Reference 22/2216/MFUL

Location Pound Road BESS Land North East Of Axminster National Grid Substation Pound Road Hawkchurch

Proposal Installation of a battery energy storage system with associated infrastructure and works.

RECOMMENDATION: Approval with conditions

Figure 1 - Indicative amendments to proposed site layout to reduce landscape impact

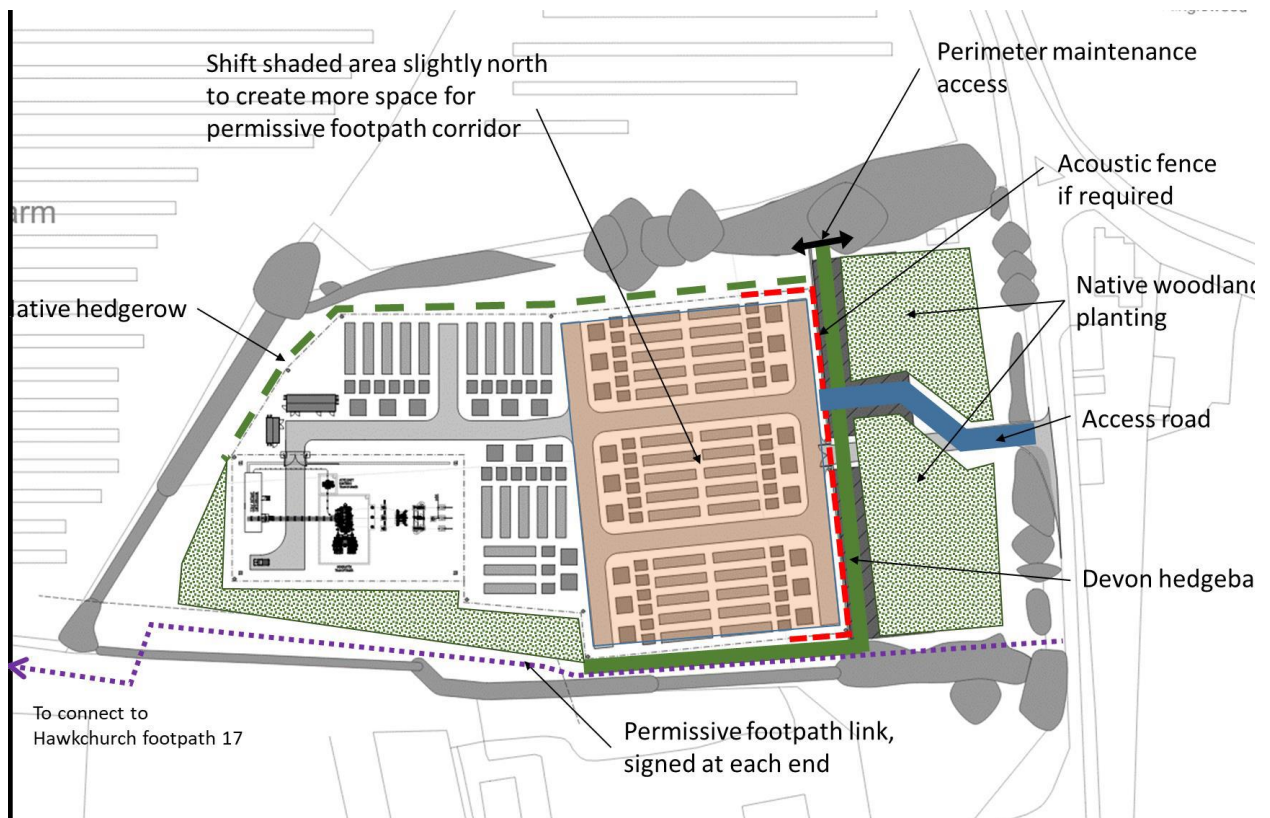
The extent of the proposed embankment retaining wall is not correctly shown on the site layout and soft landscape plans, as wing walls will be needed along the side of the embankment at its northern and southern ends and to either side of the site access road. It is also likely that railings will be required along the top of the retaining wall to protect grounds maintenance workers from falls. The railings are not shown on the submitted drawings and would add further to the visual impact of the structure.

While the proposed embankment will screen the site and proposed infrastructure from most of the frontage with Pound Road it will, itself, be a prominent, engineered feature that is uncharacteristic of the site and surrounding plateau landscape, as can be seen in the submitted photomontage for viewpoint 3 at completion of site works (year1). Furthermore the straight access road proposed through the embankment will provide a direct sightline into the site from the Pound Road entrance. A more sympathetic solution would be to provide a 1.5m high Devon hedgebank along the eastern side of the compound, planted with a mix of holly and beech, and to plant up the ground between it and the eastern site boundary as native woodland. This would tie in with existing woodland to the south and northeast. Realigning the site access road with an S-bend would prevent direct views into the site (refer fig. 1 below).

Although omitting the embankment would increase the time before effective screening of the development is achieved, the end result is likely to be more in keeping with local landscape character and provide greater bio-diversity benefit in the medium-long term.
